BAR Meeting
February 18, 2015

ISSUE: Permit to Demolish/Capsulate and Addition/Alterations

LOCATION: 222 South Fairfax Street

BAR2015-00012 & BAR2015-00013

① FIRST FLOOR PLAN - PROPOSED

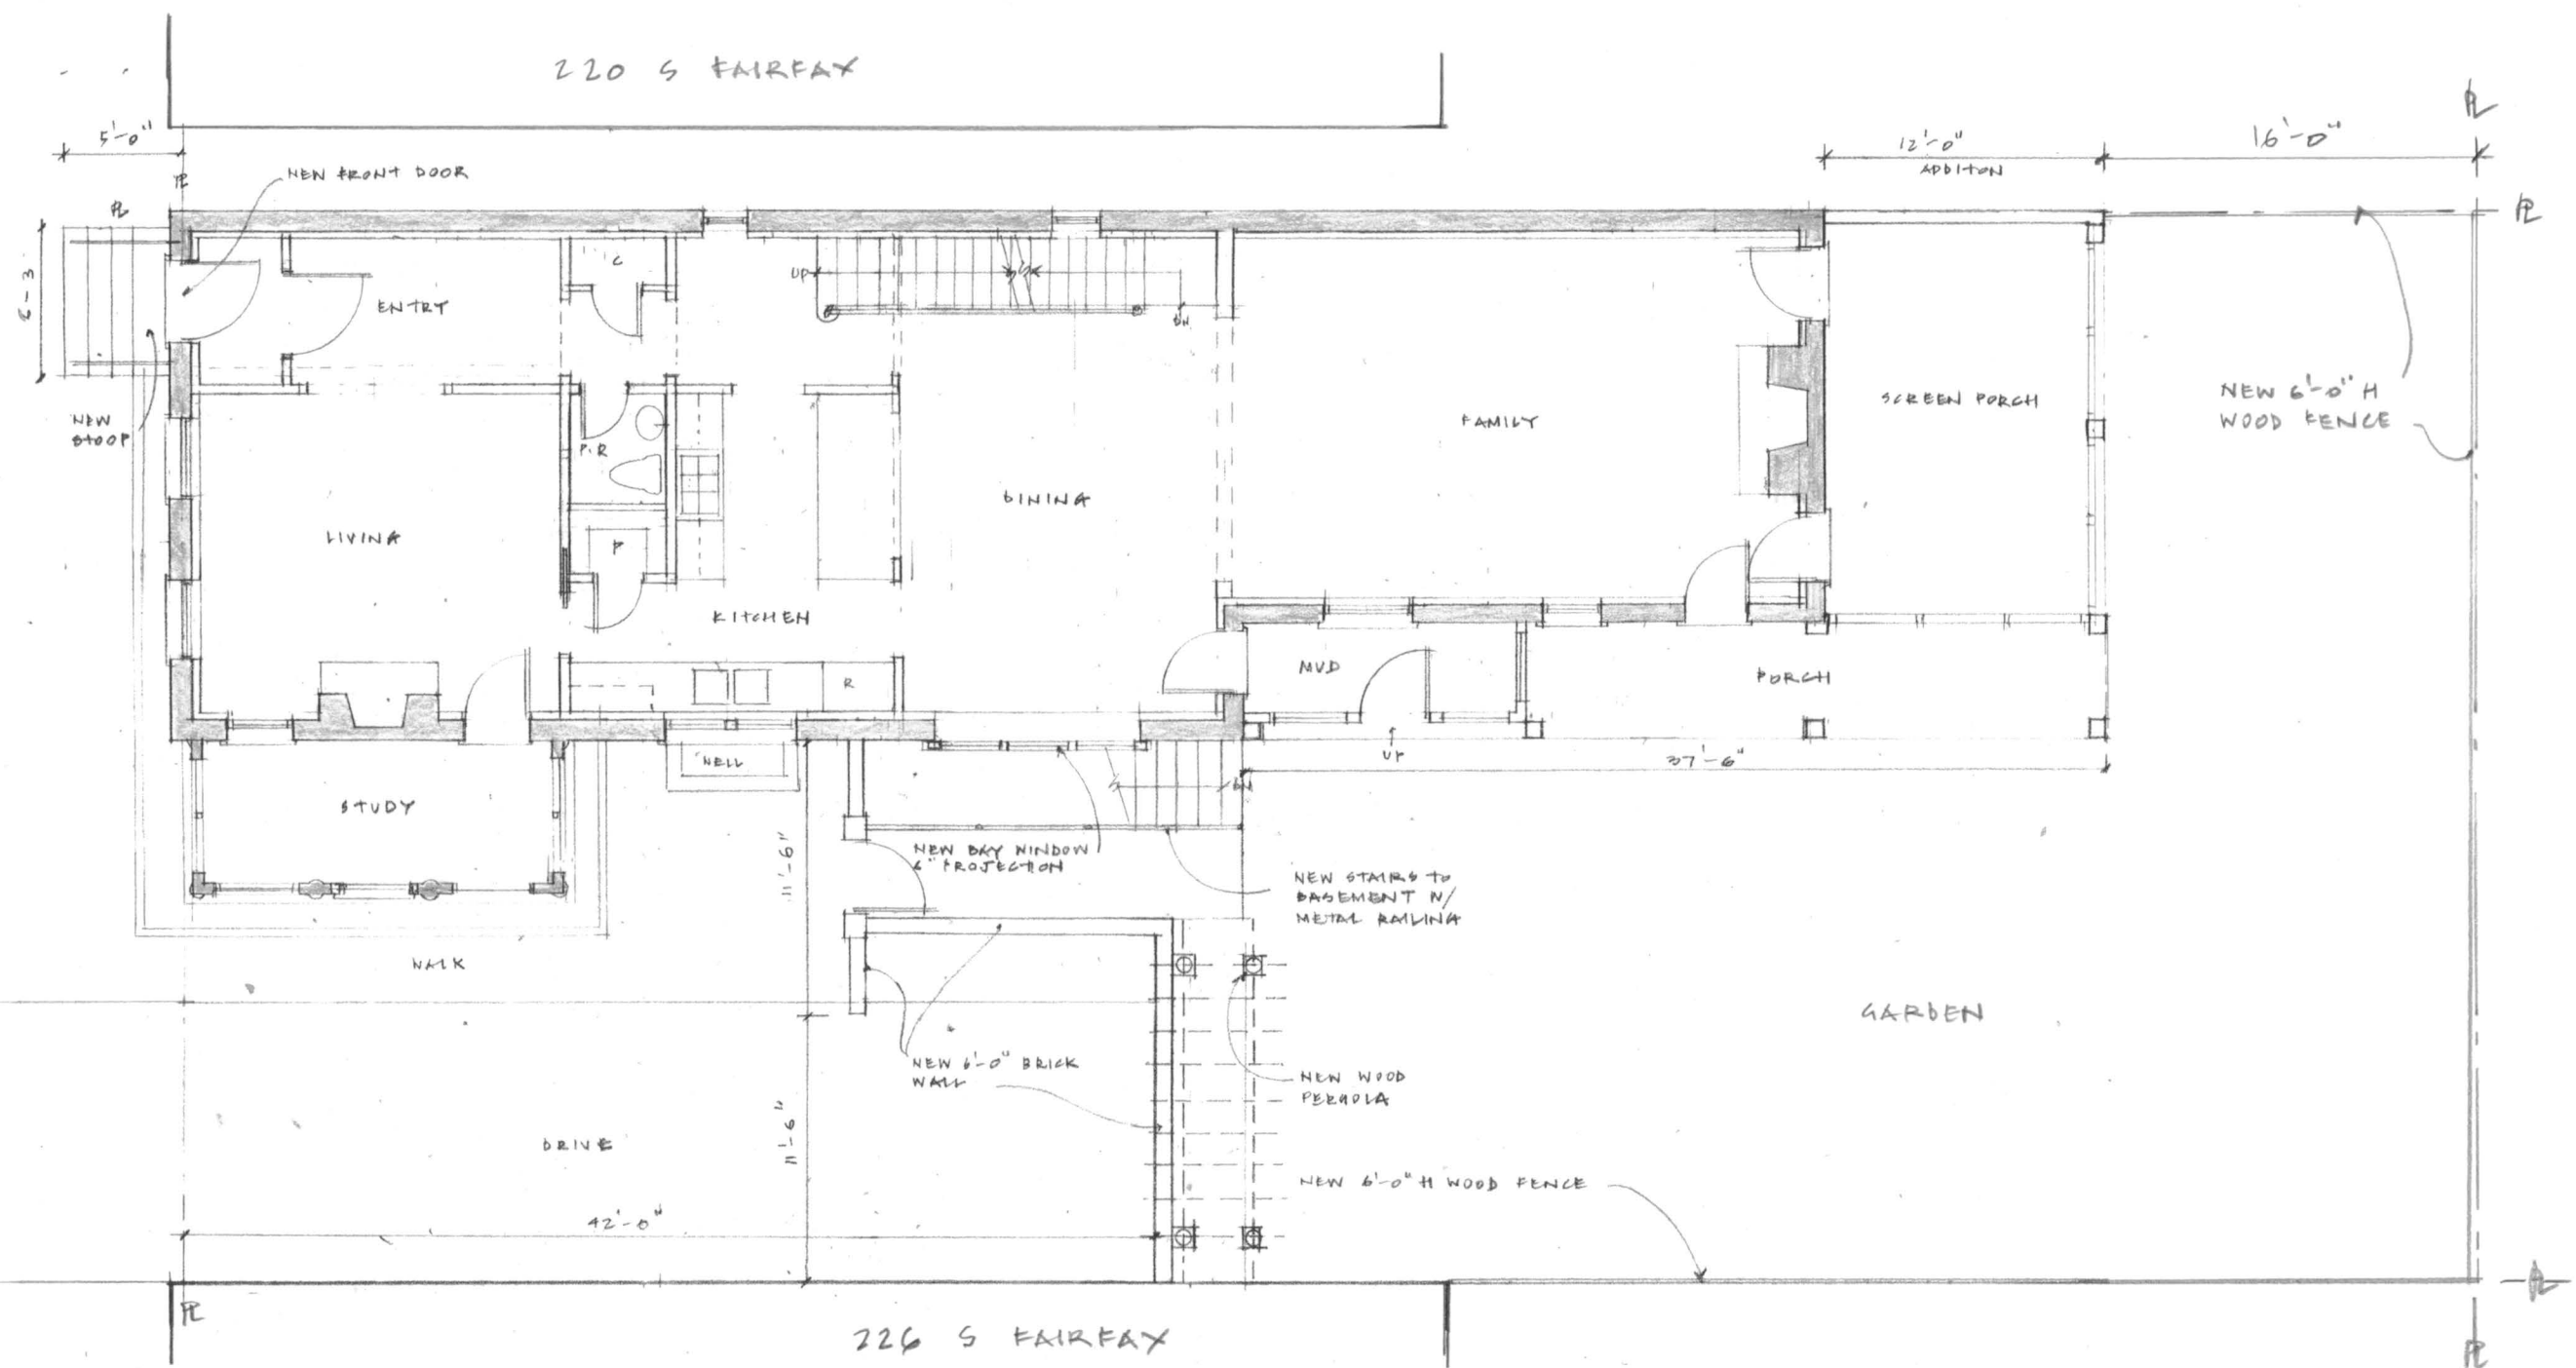
3. The applicant shall submit specifications for the replacement front door for final staff approval in conformance with the BAR's adopted policy.
4. The front stoop shall be revised to only encroach four feet into the public right-of-way, or the owner may obtain an encroachment from City Council prior to issuance of a building permit for a greater encroachment.

JELD WEN Simulated Divided Lites

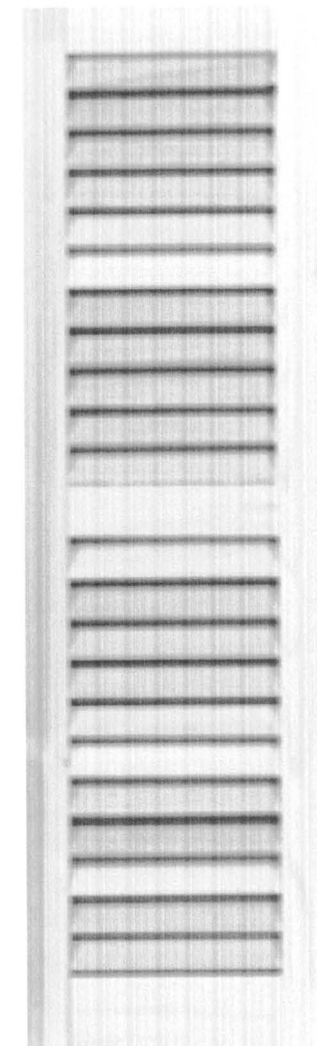
2. The front windows shall be one-over-one instead of two-over-two. The applicant shall submit specifications for final approval by staff in conformance with the BAR's adopted Window Policy.
